SERVICE INSTRUCTION CK-SI001 Rev NC Page 1 of 3

SUBJECT: *INCREASED FIRE EXTINGUISHER INSPECTIONS, OPTIONAL REPLACEMENT*

MODELS AFFECTED: *ALL CCK AND CCX AIRCRAFT WITH H3R AVIATION RT-A400 MODEL FIRE EXTINGUISHERS INSTALLED*

FIGURE 1 –Hardware Location, Looking FWD from Under the Aircraft

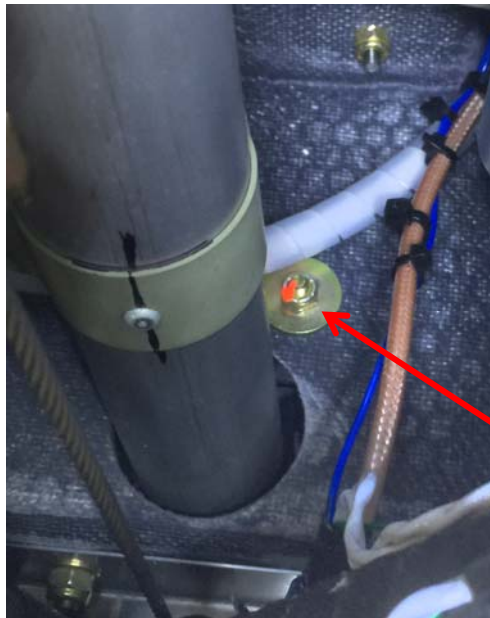
1. Read all instructions before beginning any work.
2. Remove RT-A400 fire extinguisher and follow instructions for returning the device.
3. Remove belly pan from underside of the aircraft, retaining all fasteners. Locate two nuts and washers on the forward most face of the composite seat base, just above and to the left and right of the torque tube (refer to Figure 1). Remove and retain the hardware.

5. Match drill (using a #20 bit) the new nylon strap assembly to the seat base and secure with retained screws. Install the two washers and nuts onto the threads of the screws from the aircraft underside. Torque to 38-43 in/lbs.
6. Place adhesive hook tape onto the fire extinguisher on the opposite side from the gauge. Align the top of the hook tape with the top of the label on the cylinder.
7. Install fire extinguisher into strap and verify positive contact between hook and loop tape. The nozzle must be pointed down, gauge facing forward (see Figure 2).
8. Secure the strap around the fire extinguisher and confirm positive contact between hook and loop tape. Verify the handle of the fire extinguisher is above the strap and the fire extinguisher does not interfere with, or touch, the brake lines.
